Product Change Notice (PCN)

Subject: Product change notice for DIP to SOJ adapter range.

Publication Date: 10/02/2021

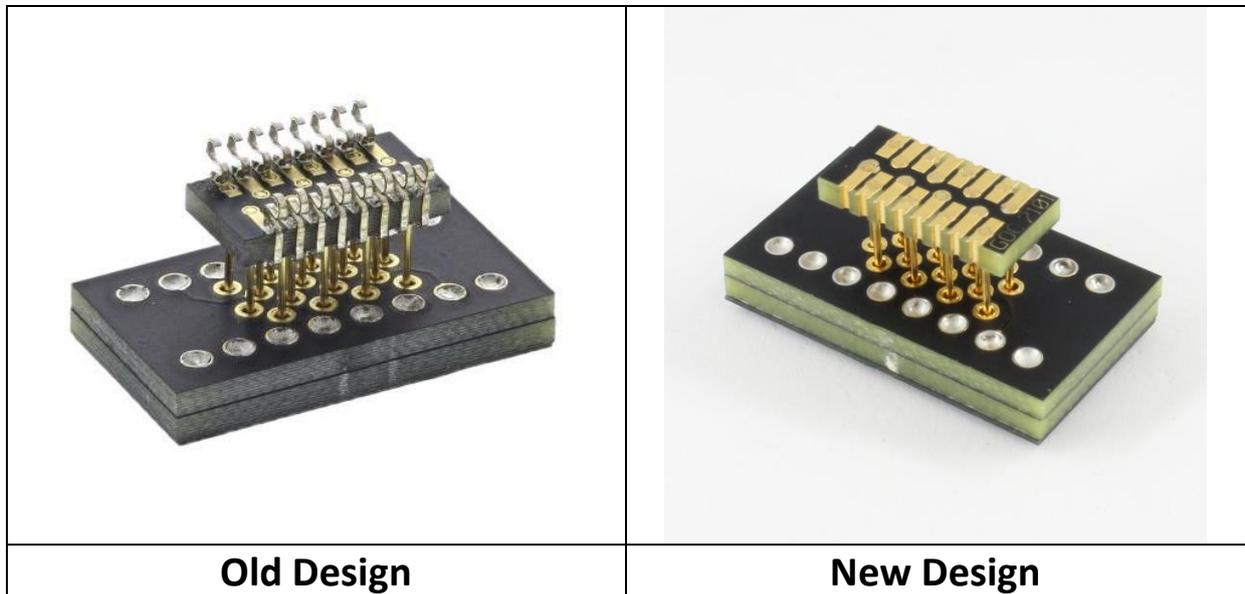
A design change has removed the pins from the bottom board which interface with the target board. They have been replaced with a modern solution which is tried and tested in our product range.

The change reduces the height of the adapter by .090[2.28mm]. There are no functional changes to the adapter.
